FCC Authorization

FCC Class II Permission change for FCC ID: 2AH25T5810

Subject: Description of Permissive Change

Dimensional drawing: Without scan coder

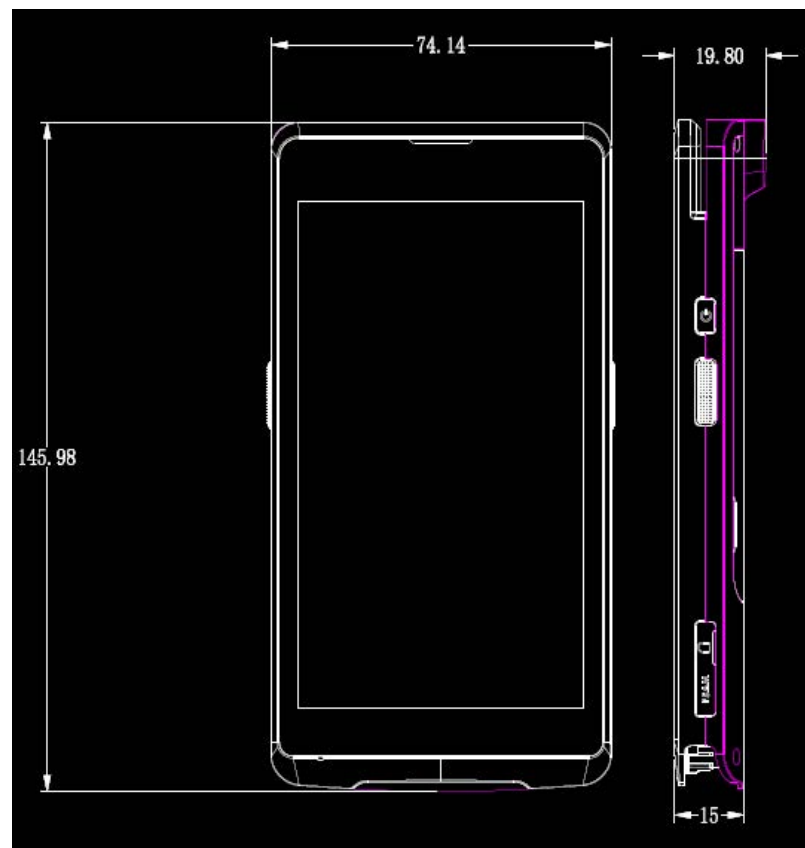
Differences between two types	without scan coder	with scan coder
WLAN and GPS antenna model	SH19453IB83-1	SH-045-016-OK-A
LTE DIV Antenna model	SH19453IA68	SH-045-017-10-OK-A
Dimensions	Length: 145.98mm Width: 74.14mm Thickness: 15.0mm	Length: 145.98mm Width: 74.14mm Thickness: 19.8mm(Scan coder part) Thickness: 15.0mm(Other part)
